1962 Corvette: Service Bulletin: Aluminum Powerglide Shift Problems

Source: Chevrolet Technical Service Bulletin

Bulletin No: DR #514

Date: January 16, 1962

FIGURE 1- 327 AND 283 POWERGLIDE TV LINKAGE COMPARISON

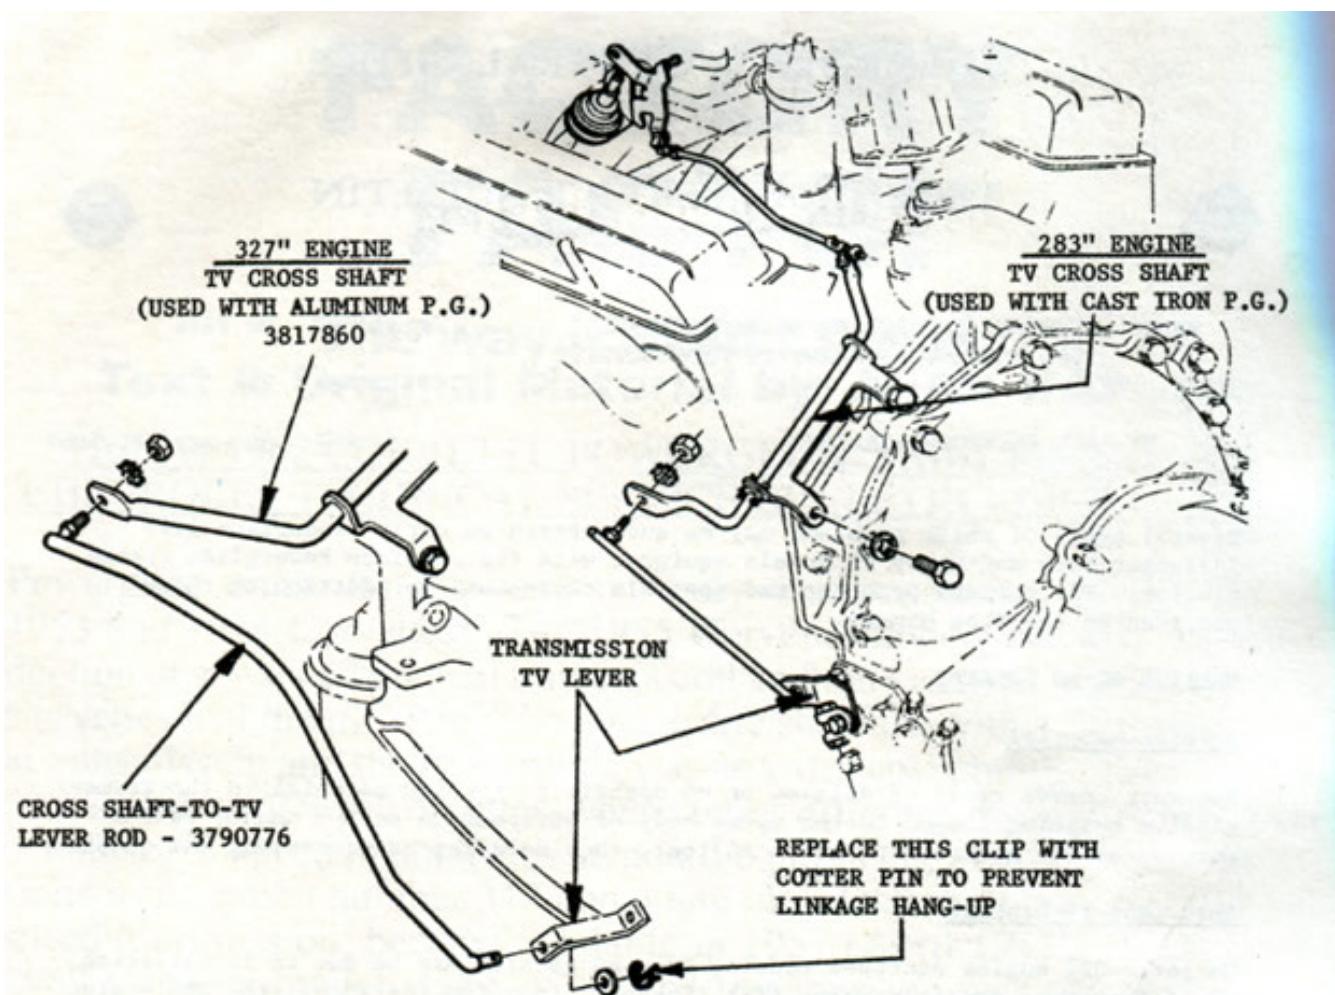
On early 327 engine equipped models, delayed upshift may be due to installation of an incorrect throttle valve (TV) linkage. In a few instances, the 283 engine cross shaft was installed instead of the correct TV cross shaft, 3817860. The TV cross shaft are easily identified as the 283 version has a bend in its outboard lever whereas the 327 cross-shaft lever is straight in this same area. (Figure 1). If the TV cross shaft was incorrect, also check the cross shaft-to-TV lever rod. As shown in Figure 1, this rod, 3790776, is formed on 327 engine applications as compared to the straight rod used on 283 engine versions.

Cross Shaft, TV (327 engine) ---- 3817860

Rod, Cross Shaft-to TV (327 engine) ----- 3790776

FIGURE 2 - ALUMINUM POWERGLIDE DIPSTICKS

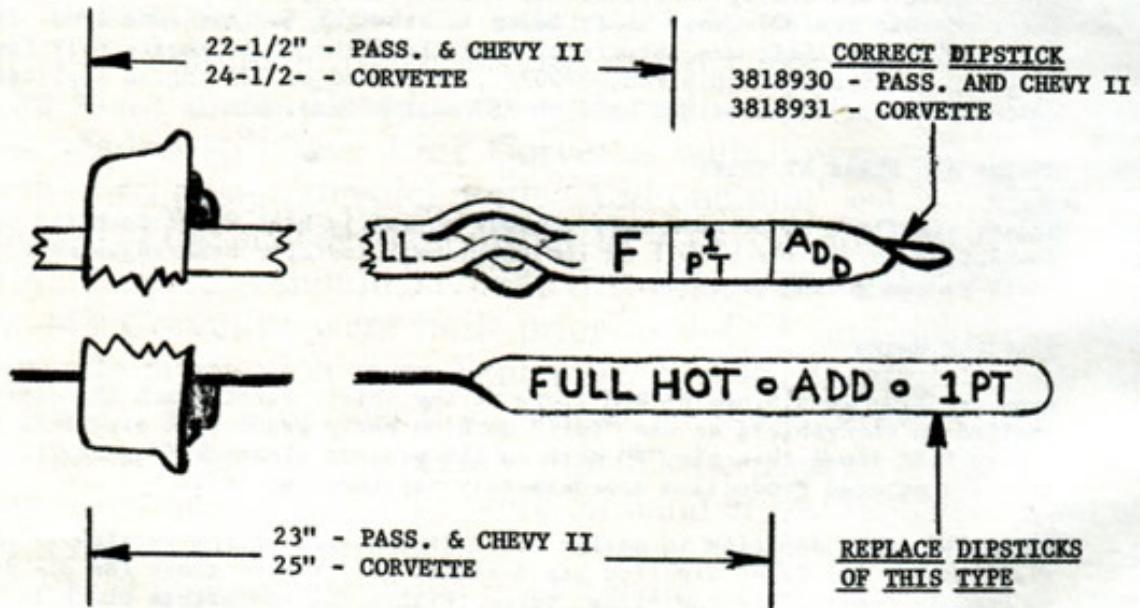
When checking complaints of RPM flare at the shift, first check the dipstick installed in the vehicle as the "Full" mark on early production dipsticks is approximately 1/2" lower than the "F" mark on the present dipstick (Figure 2). The later dipstick entered Production approximately September 4, 1961.

The early style dipstick is easily identified as its bottom section is absolutely flat whereas the later dipstick has a formed bridge just above the oil level markings to keep it centered in the filler tube. (Figure 2). A further check is to measure the distance from the top of the cap to the "Full" mark; on

Passenger and Chevy II dipsticks, this distance is now 22-1/2", as compared to 23" on the earlier dipsticks. This distance on the Corvette dipstick is now 24-1/2" as compared to 25" on earlier units.

Replace all early dipsticks with the later part when found and add oil as

required to raise the transmission oil level to the "F" mark. The later dipstick for 327 engine passenger cars and all Chevy II Models is 3818930; for Corvette, 3818931.
